# CITY OF PORTLAND, MAINE

Project Name: MMC Congress Street Hospital Building  
Project ID: 000331-2018  
Address: 22 Bramhall Street  
CBLs: 053 Doo7001  
Applicant: Maine Medical Center  
Planner: Nell Donaldson

# PLANNING BOARD REPORT

MMC Congress Street Hospital Building  
22 Bramhall Street  
Level III Site Plan  
Project #000331-2018  
53-D-7  
Maine Medical Center, Applicant

Figure 7: Proposed pick-up/drop-off circulation

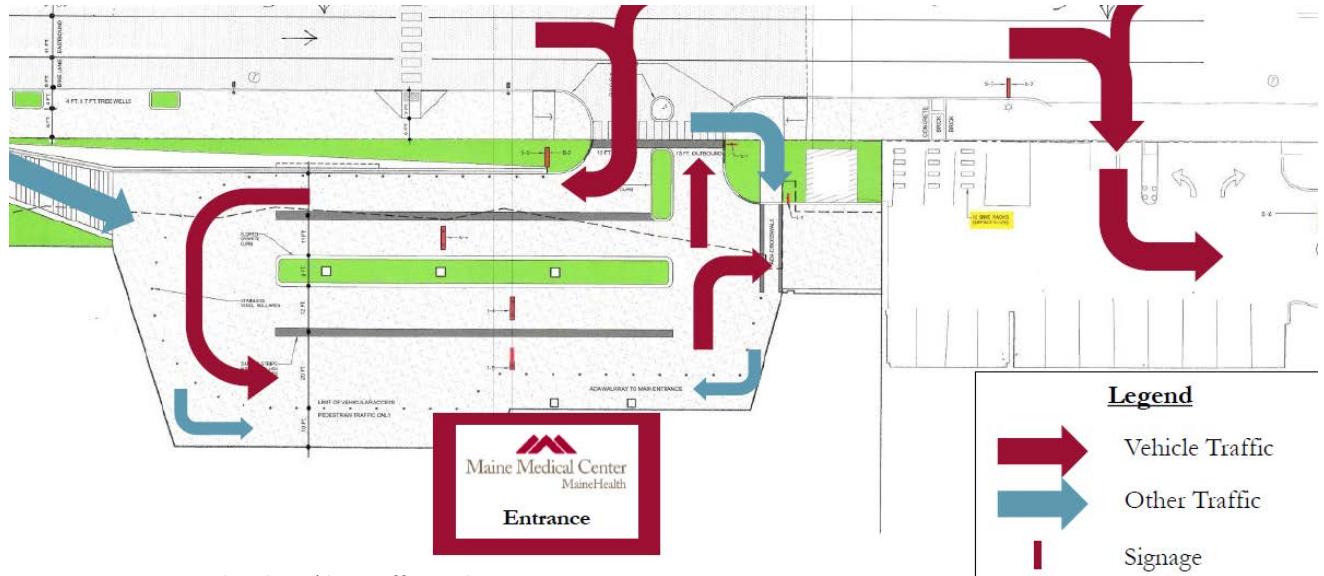
*Provide final details for improvements in the right-of-way, including sidewalks, crosswalks, curb ramps, driveway aprons, detectable warning panels, curbing, tree wells, bus shelter, curb extensions, etc.*

*Revise striping plan to retain south side parking east of the Visitor's Garage entrance/exit to just west of Bramhall where the climbing lane will transition to Shared Lane Markings (centered in the travel lane). Show (north to south) an 8' parking lane, 11' travel lanes, a 6' climbing bicycle lane, and an 8' parking lane. This section should continue to Bramhall Street to the east. Please provide plans for restriping the entirety of Congress from Valley Street to Bramhall St/Deering Ave. The outside bike lane lines are to be dashed 6" lines for a minimum of 50' in advance of an intersection and through the intersection.*

16' travel lanes are too wide for the WB approach to Valley Street. Retain existing westbound left turn pocket to Valley Street.
